Subject: Duane Arnold Energy Center
Docket No: 50-331
Op. License No: DPR-49
Response to Request for Additional Information Regarding
Duane Arnold Energy Center Relief Requests NDE-R001,
Revision 1 and NDE-R045

**Response to Request for Additional Information Regarding
Duane Arnold Energy Center Relief Requests NDE-R001, Revision 1 and NDE-R045**

Relief Request NDE-R045 (TAC No. MB4803)

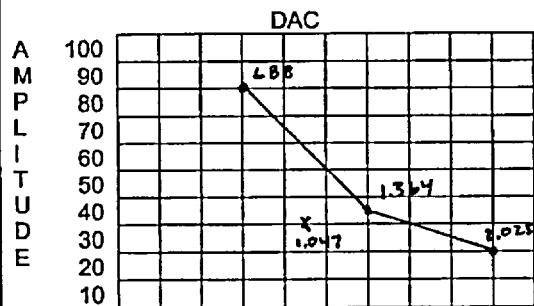
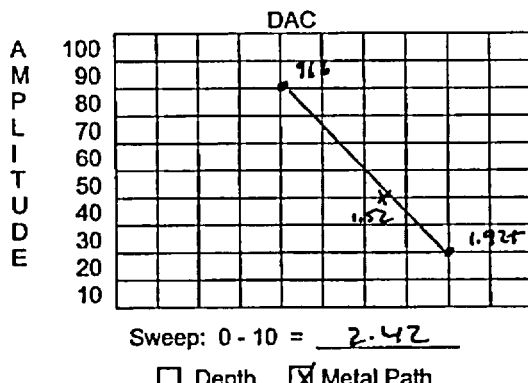
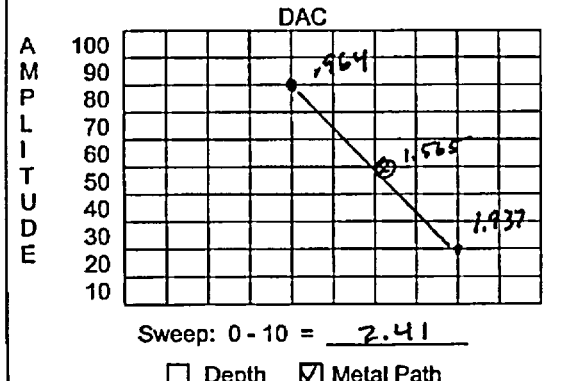
2. Please explain why the required coverage cannot be achieved using a two-sided or one-sided full Vee examination.

A two-sided examination was performed on the accessible areas. As shown on the attached calibration sheets and sketches, the maximum possible coverage was obtained with the configuration limitations. Methods used to obtain maximum coverage included reducing the dimension of the wedge edge-to-beam entry point, and increasing the beam angle.
